Technology Inclusive Content of Application Project Public Meeting

October 5, 2021
Microsoft Teams Meeting
Bridgeline: 301-576-2978
Conference ID: 968 028 925#

Overview of NRC Comments on NEI 21-07, Rev 0

Figure 3-4. Use of the F-C Target to Define Risk-Significant LBEs

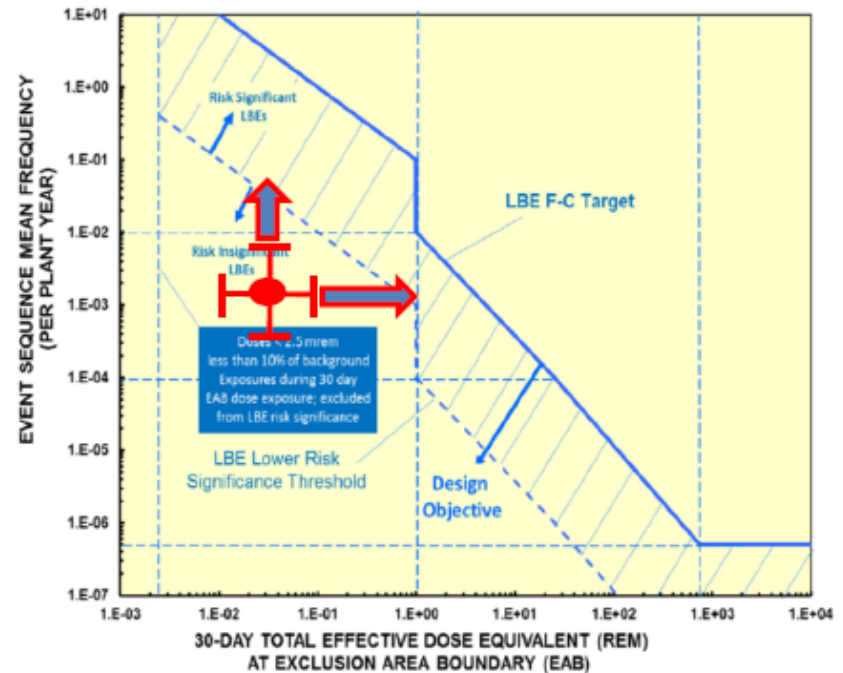
- Several criteria in 10 CFR 50.59 could apply to licensing basis event information developed from the LMP process including:
 - (c)(2)(ii) more than minimal increase in the likelihood of a malfunction of an SSC important to safety
 - (c)(2)(iv) more than minimal increase in the consequences of a malfunction of an SSC important to safety
 - (c)(2)(viii) results in a departure from a method described in the FSAR in establishing the design bases or in the safety analysis
- Criteria for evaluation of changes to the plant proposed for 10 CFR Part 53 rulemaking that assume licensing basis event information is captured in the FSAR
